Re: *Peer Review of Sound Study of Washville Carwash, Cranston, RI*

Ref: 4736

Re: *Sound Study of Washville Carwash, Cranston, RI*

Figure 1

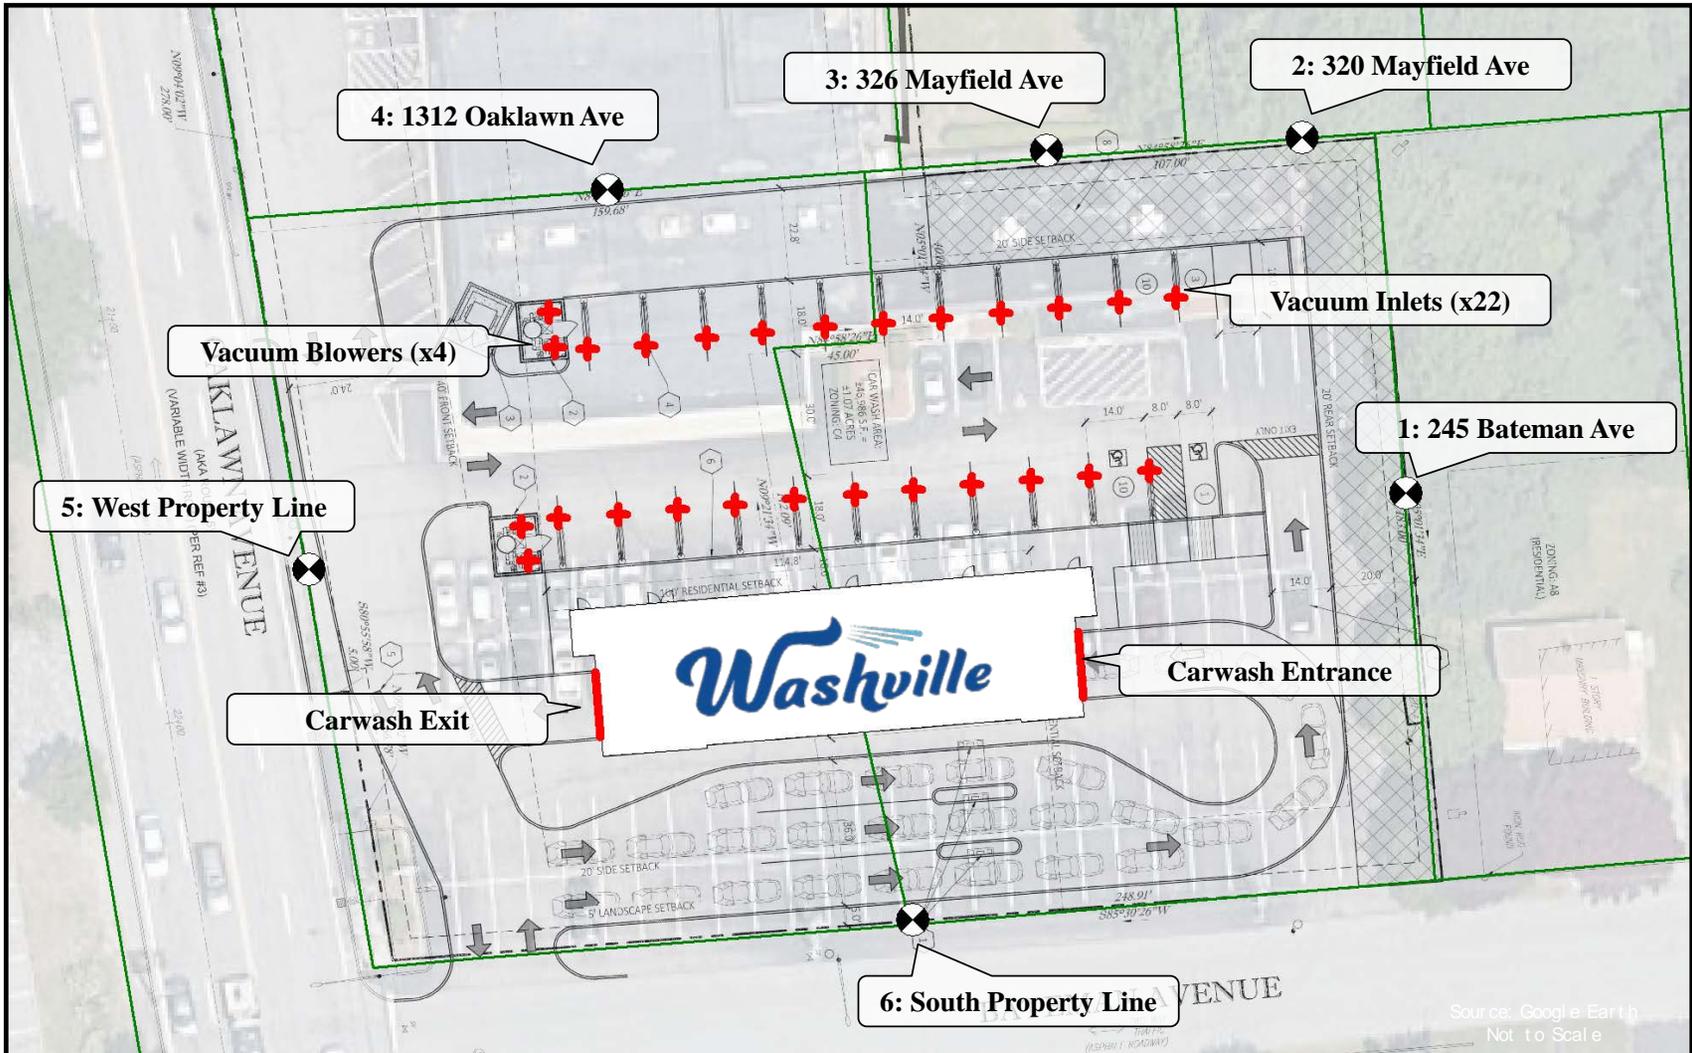
5. Mr. Bahtiarian commented that the previous Sound Study did not include an evaluation of the inlets associated with the vacuum station (i.e., the business end). Mr. Bahtiarian's comment was accurate, and the revised Sound Study includes an evaluation of twenty-two (22) vacuum inlets in the self-service area of the proposed carwash.

Sound levels were predicted for the simultaneous operation of the carwash operation, both vacuum stations and all twenty-two (22) vacuum inlets. The locations of the sound sources are illustrated in Figure 1. Table 4 summarizes the modeling results that the carwash would result in sound level impacts that range from 45 dBA to 72 dBA at the nearest property lines. The predicted sound level impacts of the carwash comply with the facility design goals for each location (see Section 2.3). The sound level impacts of the carwash at locations further away would be even less. Table 4 confirms that the proposed carwash will fully comply with the City of Cranston Noise Code.
